# UNITED STATES PATENT AND TRADEMARK OFFICE

10/693,195

<b>Office Action Summary</b>	<b>Application No.</b> 10/693,195	<b>Applicant(s)</b> GEIB, RANDALL R.	
	<b>Examiner</b> ERNESTO GARCIA	<b>Art Unit</b> 3679

## **DETAILED ACTION**

Soussloff, 4,600,334

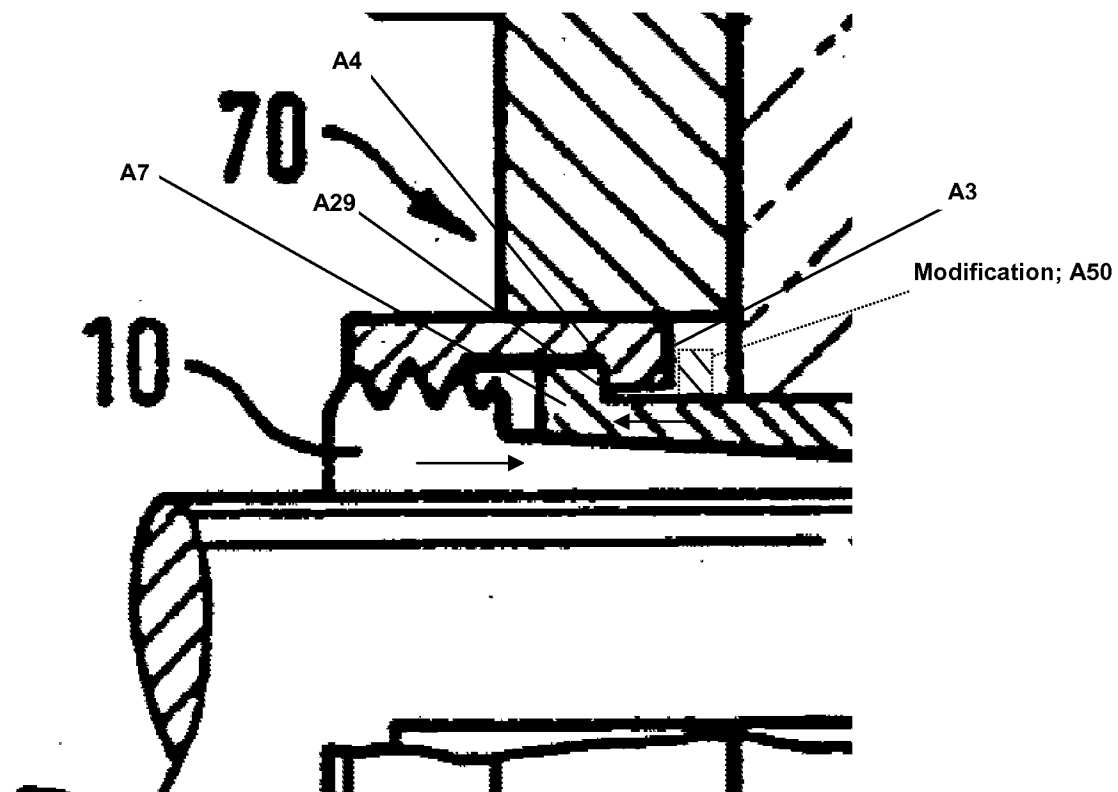
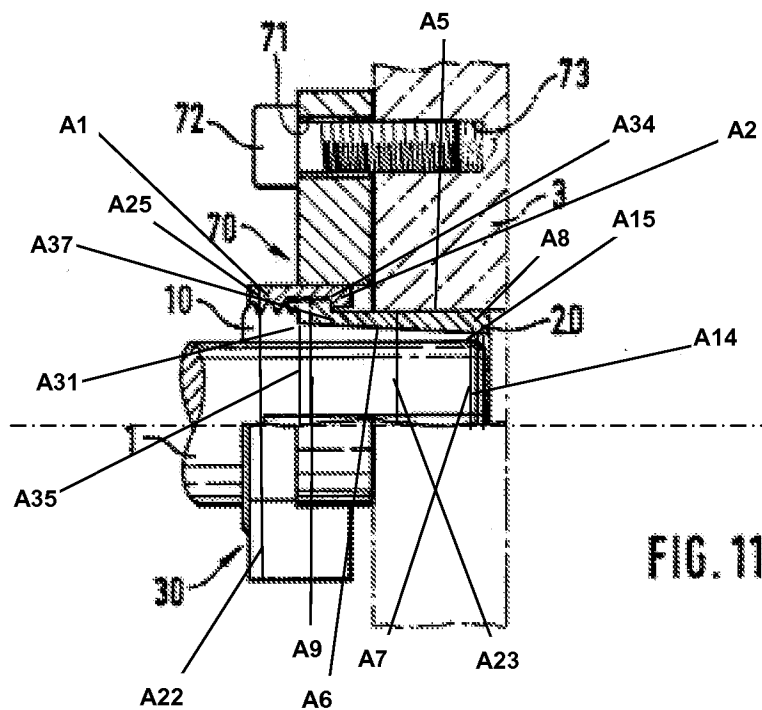
Regarding claim 24, Soussloff discloses, in Figure 9, a device comprising a nut **30**, an outer sleeve **34**, and an inner sleeve **120**. The nut **50** has a threaded portion **51** and a first connector **A1** (see marked-up attachment). The first connector **A1** has a first engagement surface **A2** and a second engagement surface **A3**. The outer sleeve **34** comprises a tapered internal surface **32** and a second connector **A4**. The second

connector **56** is connected with the first connector **A1**. The second connector **A4** has a first engagement surface **A5** and a second engagement surface **A6**. The inner sleeve **120** comprises a tapered external surface **25**, an interior bore **A2**, and a threaded portion **123**. The tapered external surface **25** corresponding in angle of taper to the tapered internal surface **32** of the outer sleeve **34**. The threaded portion **123** is remote from a forward end of the inner sleeve **120** and cooperable with the threaded portion **51** of the nut **30**.

Regarding claim 27, as best understood, the first connector **A1** is a flange and the second connector is a groove (note that features **A5** and **A6** make a groove).

Regarding claim 28, the outer sleeve **34** comprises axial slots **A7** extending longitudinally along the outer sleeve **34**. Note that the configuration and orientation of the slots provide sufficient radial flexibility.

Regarding claim 30, the outer sleeve **34** comprises a stop (the first engagement surface **A5** acts as a stop).

Geib, 5,695,297

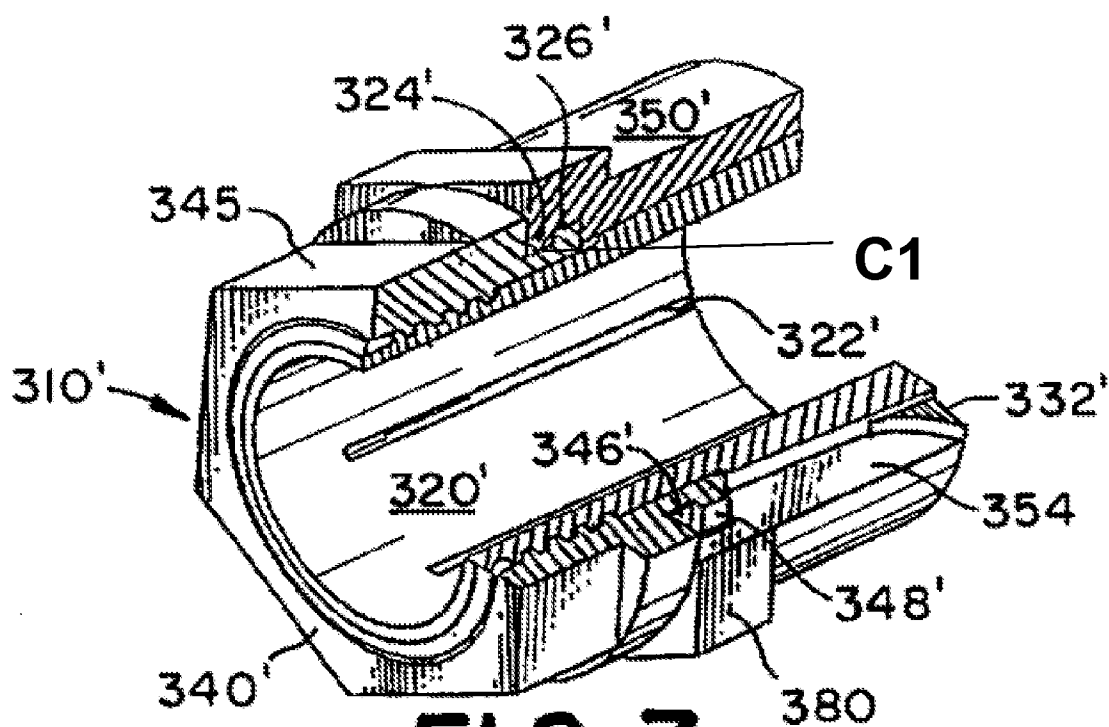
Regarding claim 3, Muellenberg, as modified, discloses the outer sleeve **20** being sufficiently resilient such that the outer sleeve **20** contracts. However, Muellenberg fails to disclose the first connector **A2** comprises a circumferential groove and the second connector **A7** comprises a flange **13** extending radially inwardly. Instead, Muellenberg teaches the reverse configuration. Geib '297 teaches, in Figure 7, a first connector comprising a circumferential groove **C1** (see marked-up attachment) on

a nut 340' and a second connector 324' comprising a flange 324' on an outer sleeve 350' and extending radially inwardly to place the outer sleeve over the nut in reverse rather than having the nut over the outer sleeve (col. 6, lines 58 - col. 7, line 9).

Therefore, as taught by Geib '297, it would have been obvious to one of ordinary skill in the art at the time the invention was made to make the first connector comprise a circumferential groove and the second connector comprise a flange extending radially inwardly to reverse the connection of the nut and the outer sleeve so that the outer sleeve is over the nut rather than the nut being over the outer sleeve.
